GMD 2019 355

Geospatial input data for the PALM model system 6.0: modelrequirements, data sources, and processing

Final response by the authors

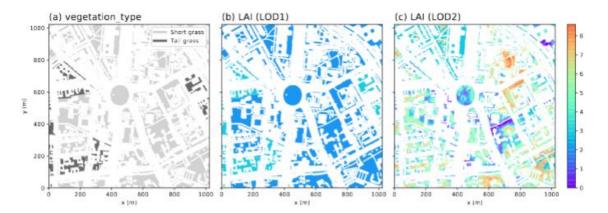
5. The paragraph in Pg3. L30, is difficult to understand. An extra figure or workflow could be useful to guide the reader.

A5. We added an illustration using LAI for a city quarter in Berlin, Germany. Here the LOD1 LAI field is determined from the vegetation_type classification and then overwritten by LOD2 data via vegetation_pars: "Figure 1 shows this hierarchy exemplary for the LAI based on available data for Berlin, Germany."
